Delaval

March 18, 1985

In accordance with the requirements of Title 10, Chapter 10, Code of Federal Regulations, Part 21, Transamerica Delaval Inc., hereby notifies the Commission of a potential defect in a component of a DSR or DSRV-16 Standby Diesel Generator. There exists a potential problem with Oil Plugs in the Crankshaft, which could result in Engine non-availability.

SKETCH SHOWING OIL PLUG ROLLED INTO CRANKSHAFT

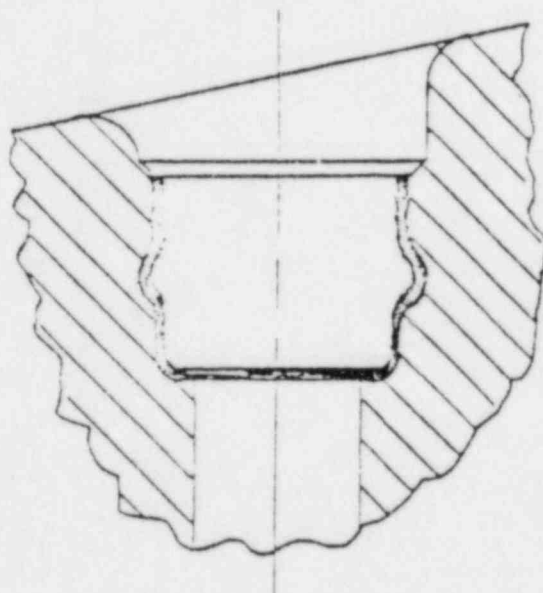
At Gulf States Utilities River Bend Site, a failed Crankshaft Oil Plug was recently discovered during routine maintenance. The failed Plug was 22 gauge material.

On 3/10/80 the Oil Plug material specification was changed from 16 gauge to 22 gauge. On 6/22/82 the material specification was changed back from 22 gauge to 16 gauge.

This Oil Plug, which seals drilled oil passages in the Crankshaft, is installed by Transamerica Delaval. The Oil Plug is rolled into the Crankshaft using an expansion tool. For your information, attached is a sketch showing the Oil Plug as it is installed in the Crankshaft.

If this Oil Plug fails, Engine availability may be affected depending on the amount of oil flow which is lost.

The Engines manufactured before 3/10/80 and after 6/23/82 should have 16 gauge Plugs unless for some reason they have been changed after shipment. Paragraph 2 indicates those 11 Engine Serial Numbers which our records show may have 22 gauge Plugs installed.

We recommend that all Engines be inspected to determine if any 22 gauge Plugs are installed. The 16 gauge Plug has a wall thickness of .0595. The 22 gauge Plug has a wall thickness of .0299. This wall thickness should be checked by measurement.

Transamerica Delaval recommends all 22 gauge Plugs be replaced with 16 gauge Plugs.

The 22 gauge Plug can be removed and replaced in the Engine without difficulty.
